*Southern California Edison Company*

February 24, 1995

Subject: Docket Nos. 50-361 and 50-362  
Control Room Area  
San Onofre Nuclear Generating Station  
Units 2 and 3

Revised Control Room Area (CRA)  
San Onofre Units 2 and 3

Figure 6.2 - 3  
 [Thick Black Outline] - CONTROL ROOM AREA  
 SAN ONOFRE GENERATING STATION - UNITS 2 & 3

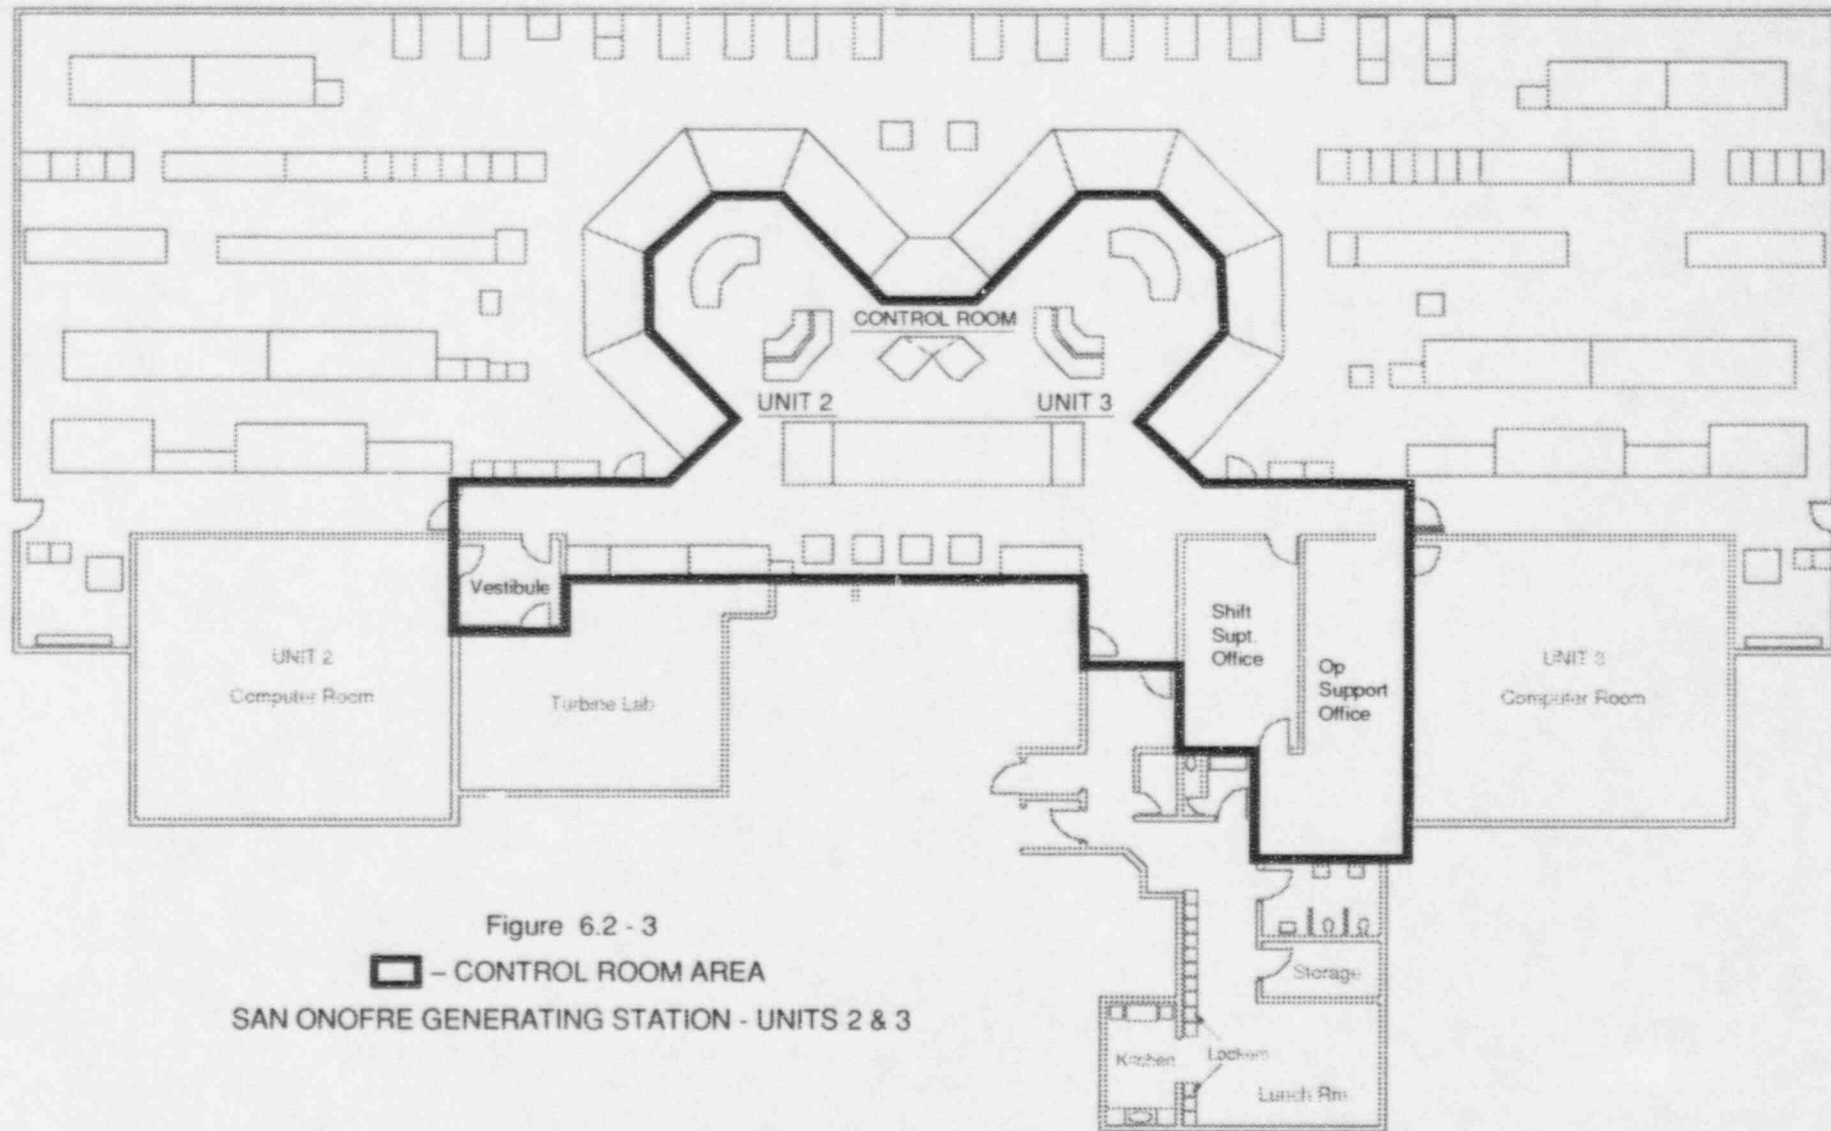
The purpose of this letter is to inform the NRC of Southern California Edison's (Edison's) intention to implement a revised Control Room Area (see enclosure) when Proposed Change Number (PCN)-299 is approved by the NRC and implemented at San Onofre. PCN-299 relocates the Control Room Area (CRA) from the administrative section of the Units 2 and 3 Technical Specifications (TSs) to the Licensee Controlled Specifications (LCS) as permitted by NUREG-1432, "Standard Technical Specifications Combustion Engineering Plants." When implemented, the new CRA in the LCS will replace the existing TSs CRA.

Reference 1 also informed the NRC of Edison's continuing evaluation on the need for the SRO holding the Control Room Command function to check instrumentation in the adjacent hallways. The new CRA incorporates the results of this evaluation.

To ensure the new CRA supports the RG 1.114 Position C.2.3 requirement of "in the audible range of the reactor operator at the controls," we demonstrated that audible summons for the SRO with the Control Room Function could be heard in the Operations Support Office from the Unit 3 control room entrance.
